NOTICE OF PROPOSED ISSUANCE OF AMENDMENT TO PROVISIONAL OPERATING LICENSE

PROPOSED AMENDMENT TO PROVISIONAL OPERATING LICENSE

CHANGE NO. 4 TO TECHNICAL SPECIFICATIONS

UNITED STATES ATOMIC ENERGY COMMISSION
SAFETY EVALUATION BY THE DIVISION OF REACTOR LICENSING
DOCKET NO. 50-220
NIAGARA MOHAWK POWER CORPORATION
NINE MILE POINT NUCLEAR STATION
POWER INCREASE

FIGURE 2.1.2 Revised

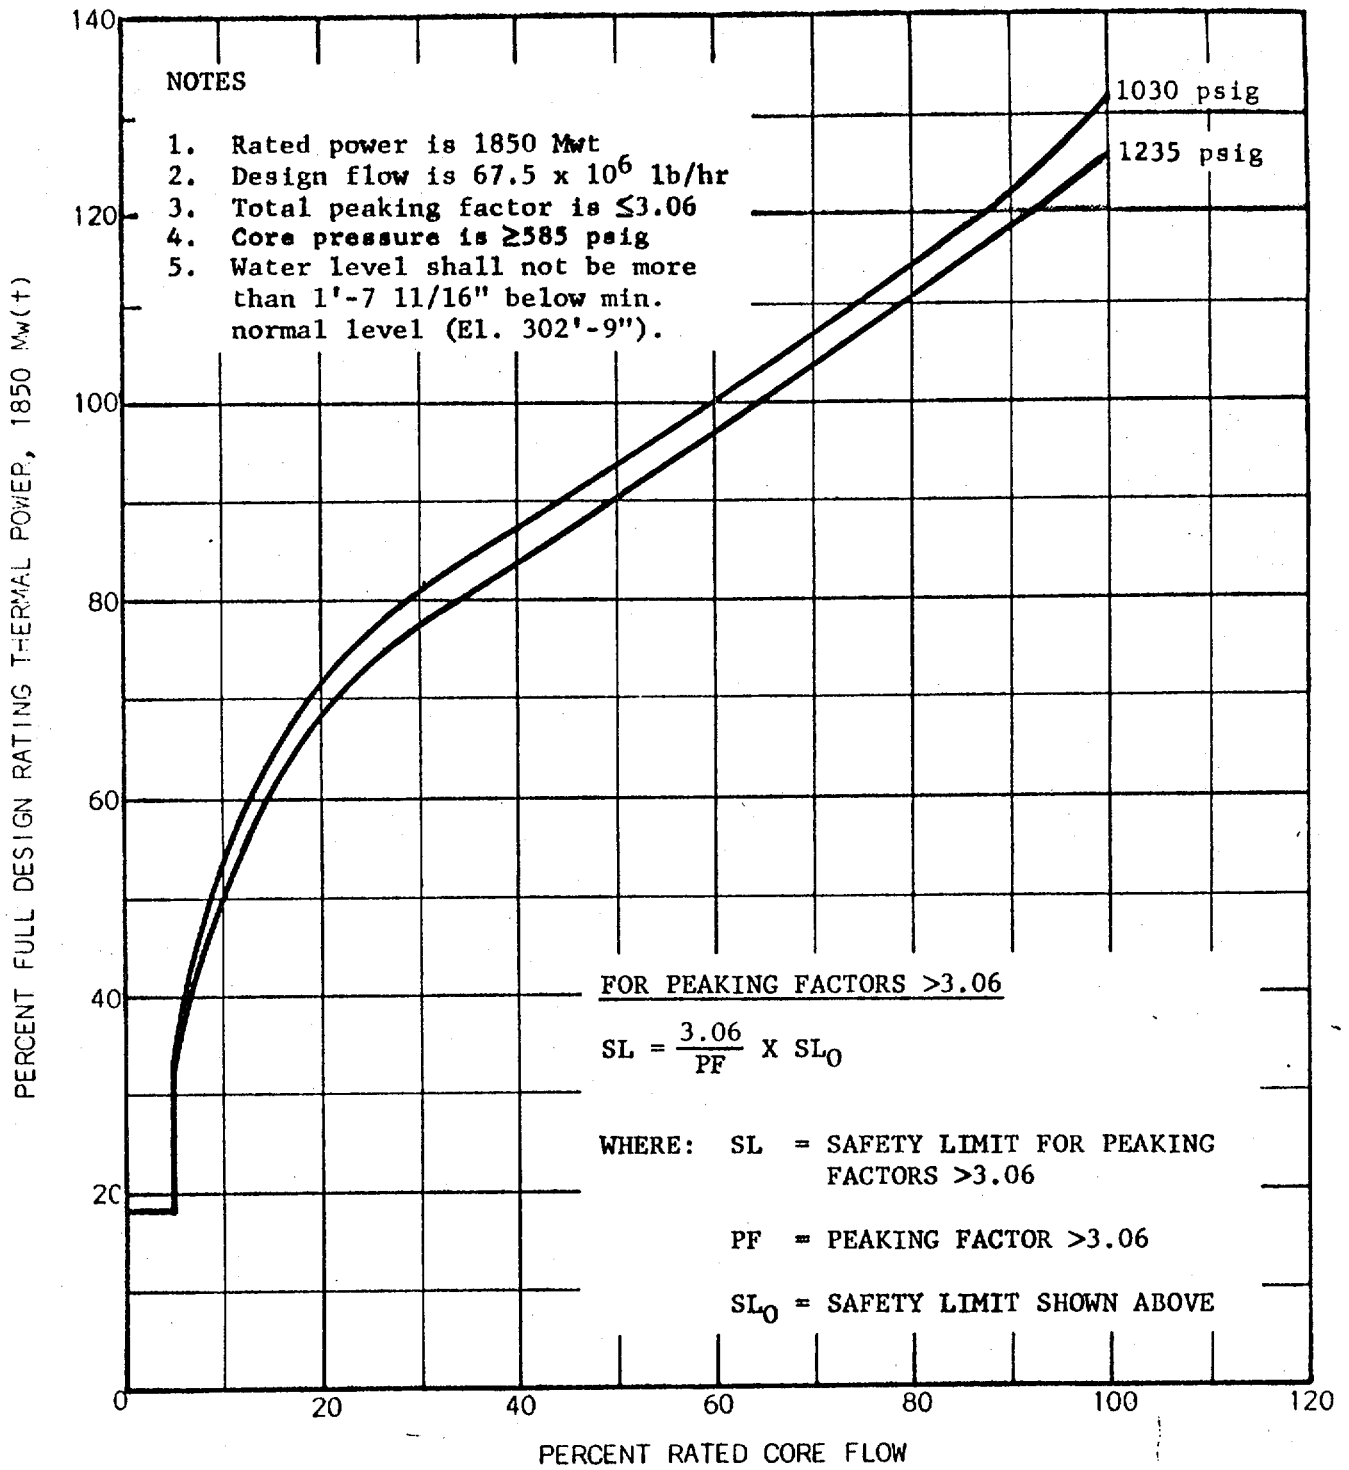
Specification Figure 2.1.1 - page 10

Replace "Figure 2.1.1" with the attached "Figure 2.1.1 Revised".

Figure 2.1.2 Revised

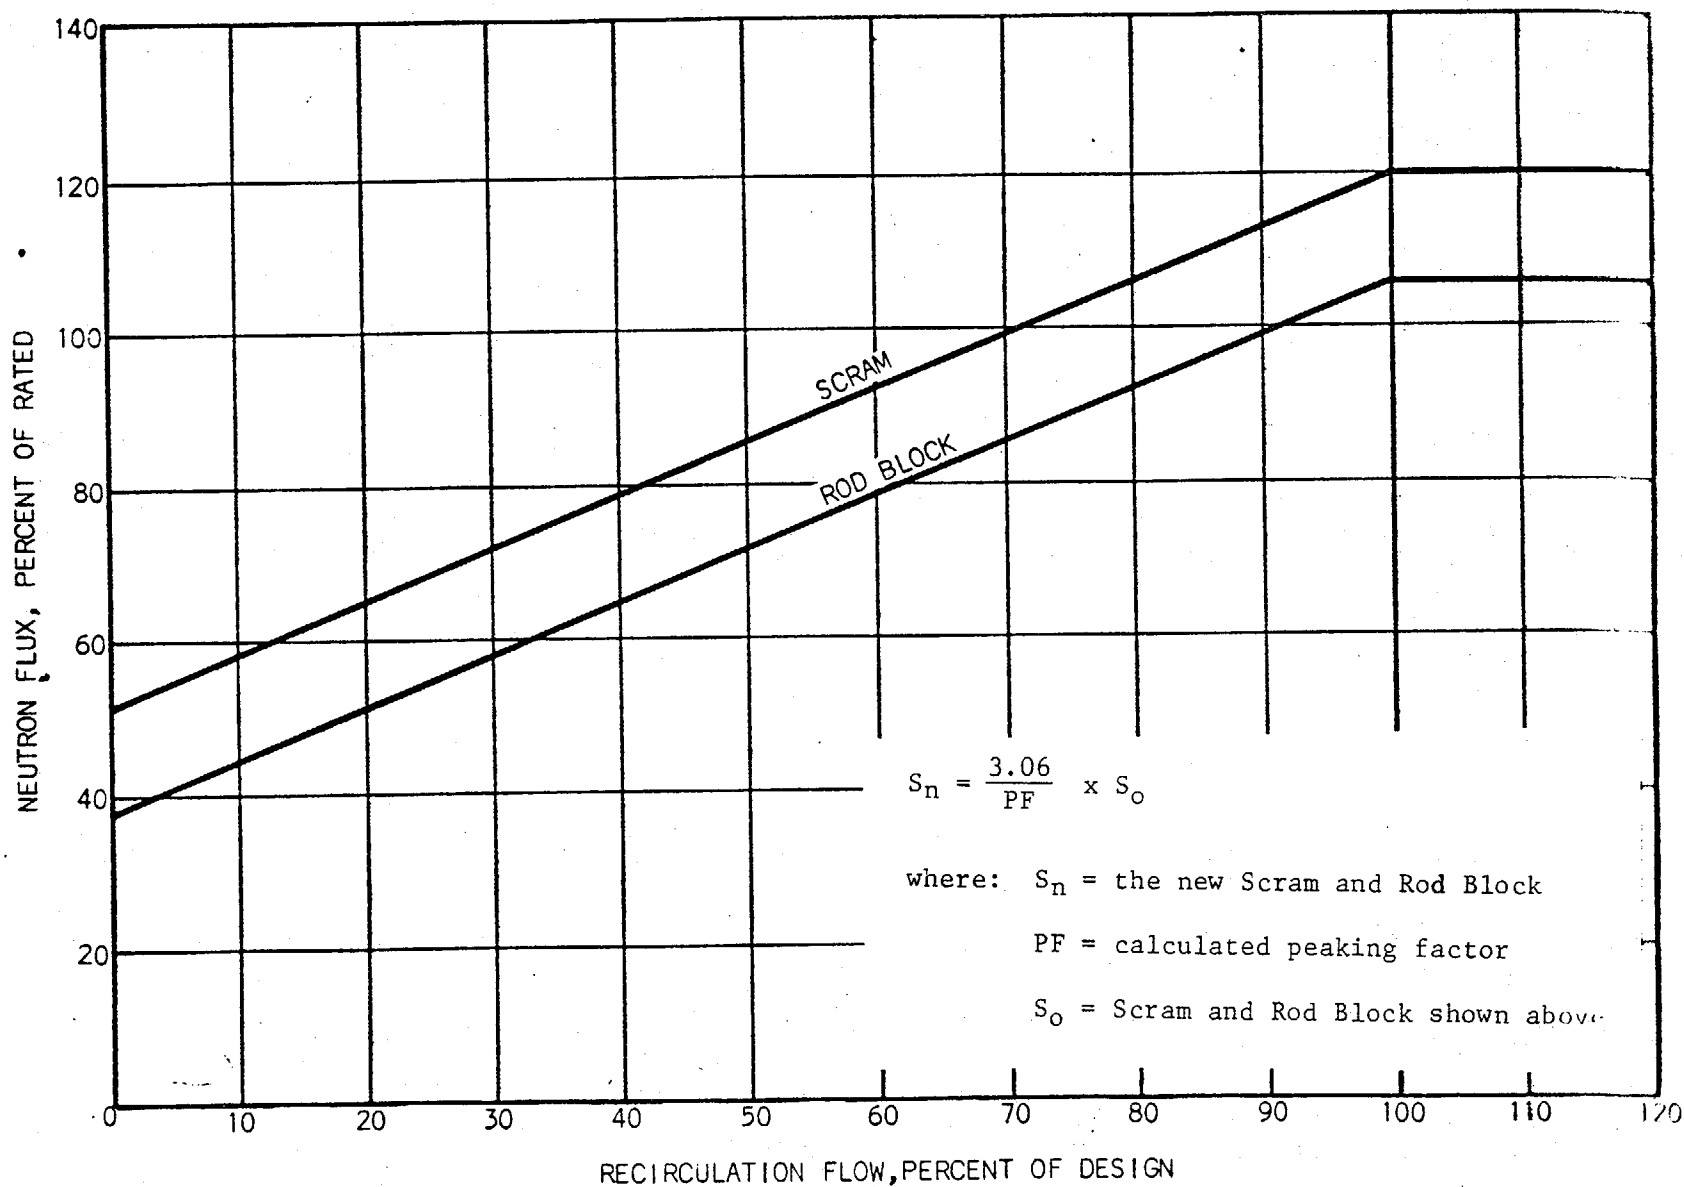
"The thermal hydraulic safety limit of Figure 2.1.1 Revised was based on a total peaking factor of 3.06, and an adjustment is required in the unusual event of higher peaking factors. Likewise, power indication at which scram occurs must be adjusted to assure MCHFRs above 1.0 for expected transients in this derated condition. This is provided by application of the formula on Figure 2.1.2 Revised."

Specification Figure 2.1.1 - page 16

Replace "Figure 2.1.2" with attached "Figure 2.1.2 Revised".

"c. At least daily during reactor power operation, the reactor neutron flux peaking factor shall be estimated and the flow-referenced APRM scram and rod block signals shall be adjusted, if necessary, as specified in Figure 2.1.2 Revised."
